UNITED STATES PATENT AND TRADEMARK OFFICE

APPLICATION NO.	FILING DATE	FIRST NAMED INVENTOR	ATTORNEY DOCKET NO.	CONFIRMATION NO.
09/989,845	11/21/2001	James E. Lerch JR.	011215	1251

Office Action Summary

DETAILED ACTION

3,388,892 (Case)

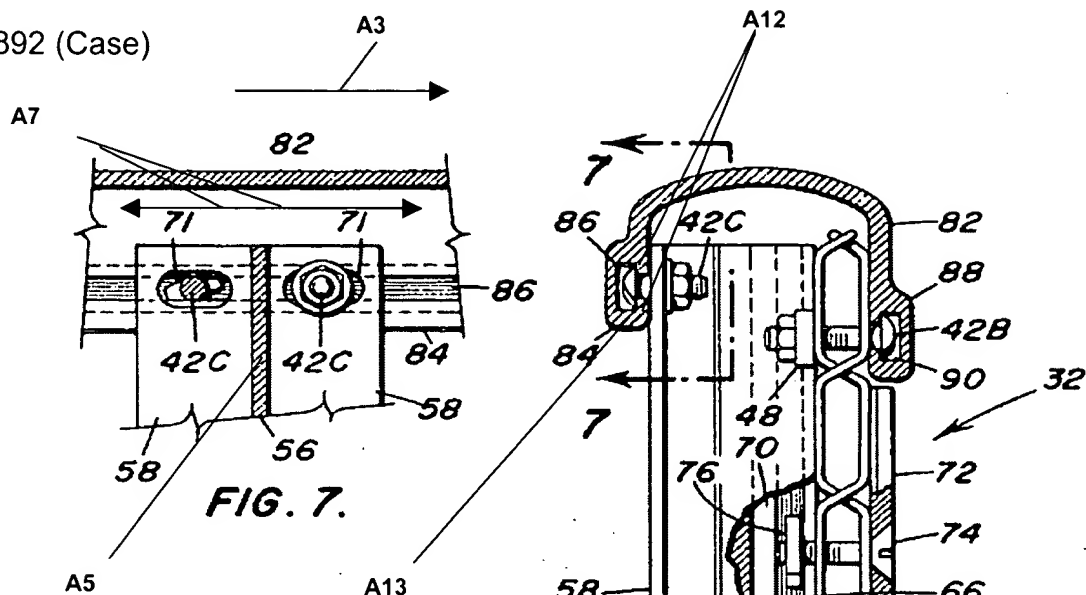
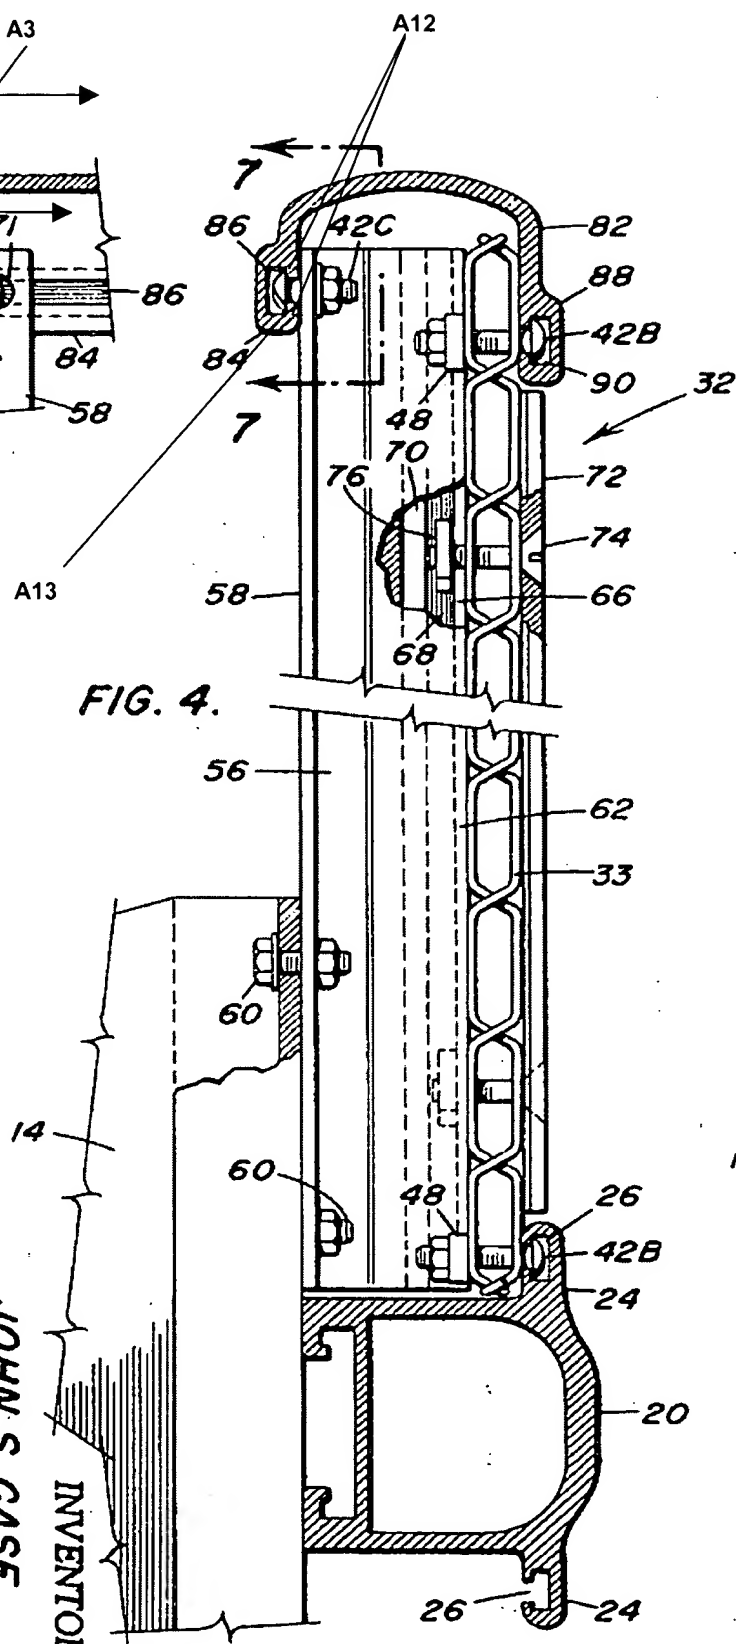
Claims 1-3, 8-10 and 18-20 are rejected under 35 U.S.C. 102(b) as being anticipated by Case, 3,388,892 (see reproduced marked-up attachment).

Regarding claim 1, Case discloses an improvement, in a barrier, comprising at least one longitudinally extending railing **82**, vertically extending posts **56**, and fastening means **42c**.

The railing **82** has at least one generally T-shaped channel **86**. The channel **86** extends in a longitudinal direction **A3** of the railing **82** and at least one leg **A12** of the channel **86** extends inwardly within the channel **86**.

The posts **56** each have an elongated body **A5** and at least two flange segments **58**. The flange segments **58** extend outwardly in opposite directions **A7** and have at least one perforation **71** in each of the flange segments **58**.

The fastening means **42c** are slidably embraced within the channel **86** and the fastening means **42c** extend through the perforation **71** in the flange segments **58** and fastened to the posts **56**.

Regarding claims 2, 9 and 19, the T-shaped channel **86** has an inwardly extending tab **A12** at an end of a leg **A13** of the channel **86**.

Regarding claim 18, Case discloses in Figures 1-3 an apparatus comprising a barrier **32**. The barrier **32** has at least one longitudinally extending railing **82**, vertically extending posts **56**, and fastening means **42c**.

Regarding claims 3, 10 and 20, the railing 82 has another T-shaped channel 90 thereby the railing 82 has at least two T-shaped channels 86,90.

However, McMullin does not show another perforation in the other one of the flange segments **A6** thereby making each of the flange segments **A6** having at least one perforation to connect the rail. Case teaches in Figure 7 at least one perforation **71** in each flange segment **58** to connect a rail to a post. Therefore, as taught by Case, it would have been obvious to one of ordinary skill in the art at the time the invention was made to include at least one perforation **32** in each of the flange segments **A6** to connect the rail to the posts.

3,258,250 (McMullin)

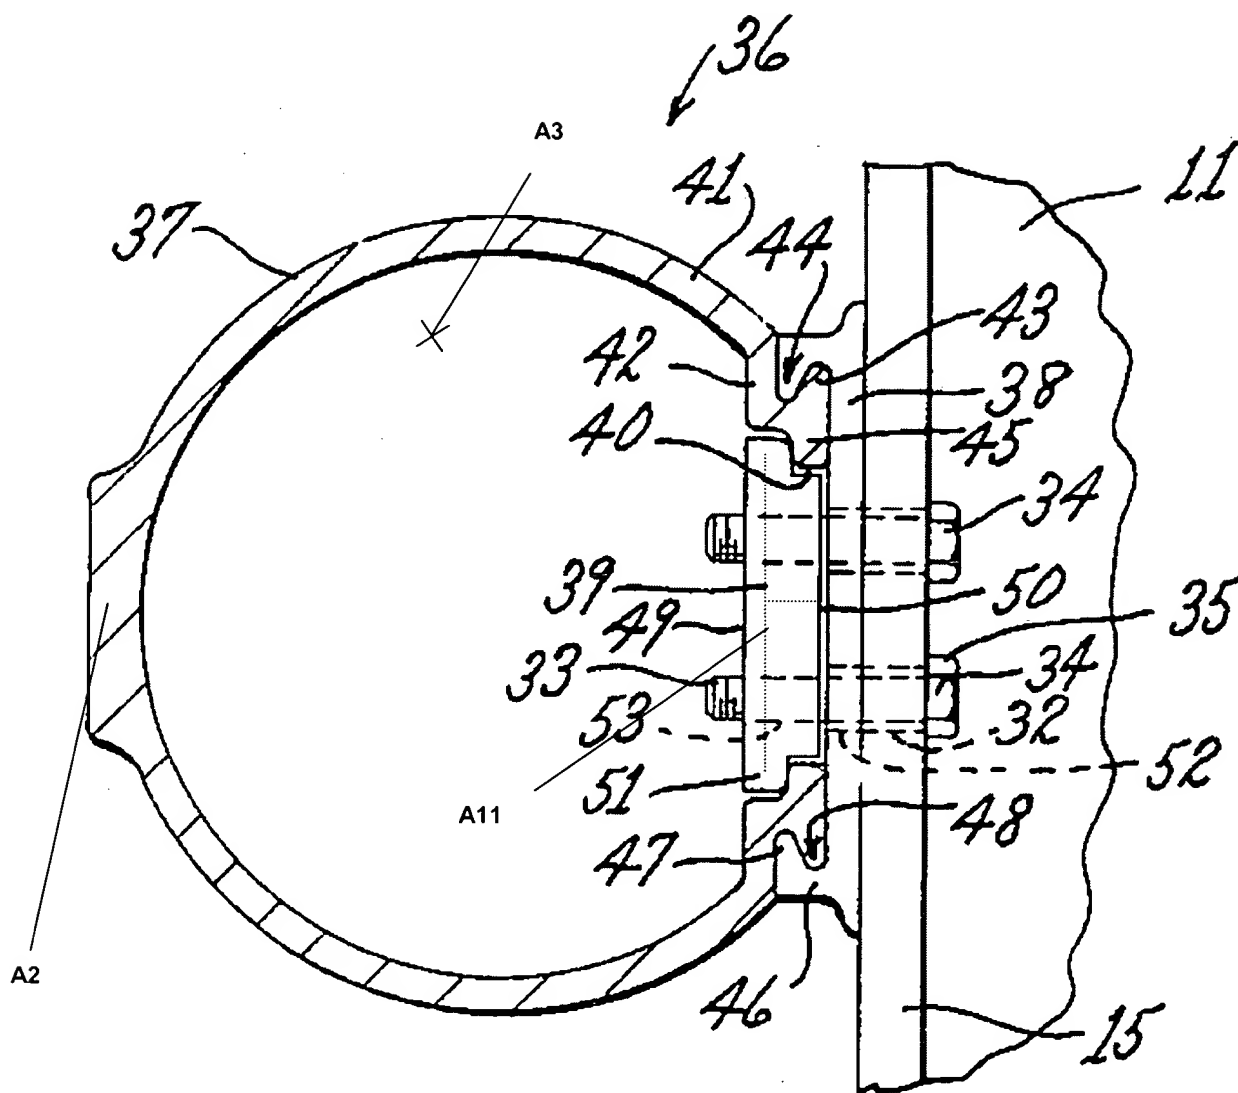
Claims 1-2, 4, 5, 7-9, 11, 12, 14-18, 19, 22 and 24 are rejected under 35 U.S.C. 103(a) as being unpatentable over McMullin, 3,258,250 (see marked-up attachments provided on last office action), in view of Case, 3,388,892.

Regarding claim 1, McMullin discloses an improvement comprising at least one longitudinally extending railing 37, vertically extending posts 11, and fastening means 34. The railing 37 has at least one generally T-shaped channel A2. The channel A2

extends in a longitudinal direction **A3** of the railing **37** and at least one leg **45** of the channel **A2** extends inwardly within the channel **A2**. The posts **11** each have an elongated body **14** and at least two flange segments **A6**. The flange segments **A6** extend outwardly in opposite directions **A7** and have at least one perforation **32** in at least one of the flange segments **A6** (Fig. 1; attachment). The fastening means **34** are slidably embraced within the channel **A2** and the fastening means **34** extend through the perforation **32** in the flange segments **A6** and fastened to the posts **11**.

Regarding claims 2, 9 and 19, the T-shaped channel **86** has an inwardly extending tab **45** at an end of a leg **41** of the channel **A2**.

Regarding claims 4, 11 and 22, the railing **37** has a T-shaped channel **A11**.

Regarding claims 5 and 12, the flange segments **A6** extend at 180 degrees angle to each other.

Regarding claim 18, McMullin discloses in Figures 1 and 3 an apparatus comprising a barrier **36**. The barrier **36** has at least one longitudinally extending railing **37**, vertically extending posts **11**, and fastening means **34**.

The railing **37** has at least one generally T-shaped channel **A2**. The channel **A2** extends in a longitudinal direction **A3** of the railing **37** and at least one leg **45** of the channel **A2** extends inwardly within the channel **A2**.

The posts **11** each have an elongated body **14** and at least two flange segments **A6**. The flange segments **A6** extend outwardly in opposite directions **A7** and have at least one perforation **32** in each of the flange segments **A6**.

The fastening means **34** are slidably embraced within the channel **A2** and the fastening means **34** extend through the perforation **32** in the flange segments **A6** and fastened to the posts **11** to provide a variably select elevation of the longitudinally extending railing.
